North Fairfax Drive Neighborhood Complete Streets Project – Community Engagement Summary

Figure 1: Safety - Proposed Conditions

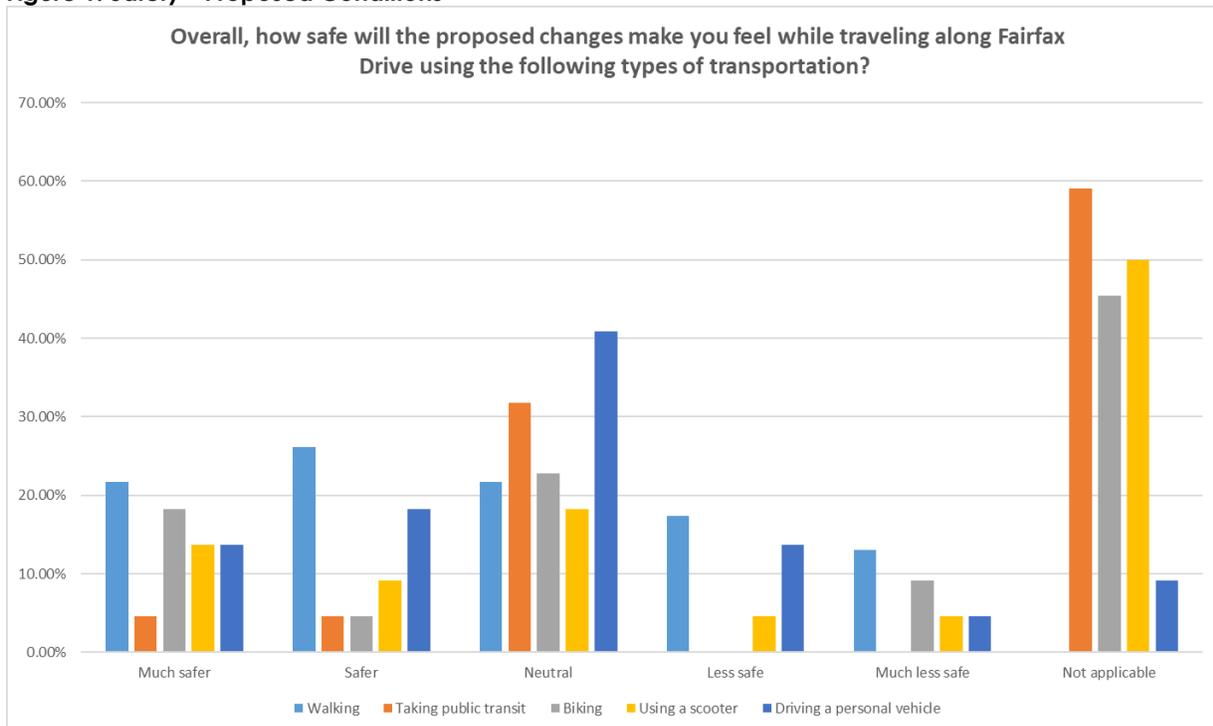
- *Concern about removal of the western most mid-block crossing* – The majority of narrative comments expressed concern about removal of the mid-block crossing closest to the intersection with North Barton Street. The two crosswalks on Fairfax Drive east of the intersection of Fairfax Drive and North Barton Street are legacy crosswalks that were used to access Rocky Run Park before it was redeveloped, and at a time when the intersection of North Barton Street and North Fairfax Drive was not controlled with an All Way Stop. The Park now has steeper slopes and a fence preventing direct access using these crosswalks. Rocky Run Park is now accessible from N Barton St or further east along Fairfax Drive, where the fence opens. The project proposes to remove one of the three mid-block crosswalks for the following reasons:

- *Strong support for curb extensions and shortened crossing distance* – The majority of comments from survey participants and shared directly with Staff indicate support for the addition of curb extensions, high visibility paint and a shortened crossing distance. Comments indicated this to be a busy stretch of road with many modes of travel, and many types of travelers, including young children.

- *Choice of materials* – Some survey respondents expressed preference for the brick style appearance of the current pedestrian crossings, while also indicating that they liked the proposed high visibility crossing. This brick paving material does not meet current County standards, and is insufficient for visibility, particularly at nighttime. The revised concept seeks to match existing conditions near the sidewalk ramps where possible. This maintains more of the existing brick sidewalk on the north side, while providing the high visibility crossing in the roadway.

- It is safer for people walking to cross where people driving have a traffic control device, such as a stop sign: The existing crosswalk planned for removal is less than 100' away from the crosswalk at North Barton Street which is an All Way Stop controlled intersection;

- The way N Fairfax Drive and N Barton Street intersect makes it difficult for people driving to see people in this crosswalk before they make their turn: The skew of the intersection geometry inhibits sight lines for northbound vehicles making a right turn onto North Fairfax Drive, which puts pedestrians crossing at this crossing at risk;

- Turning Vehicle Analysis was performed and showed that larger vehicles making a right turn from northbound North Barton Street are not able to completely straighten out their vehicle until they have already crossed the existing crosswalk planned for removal.
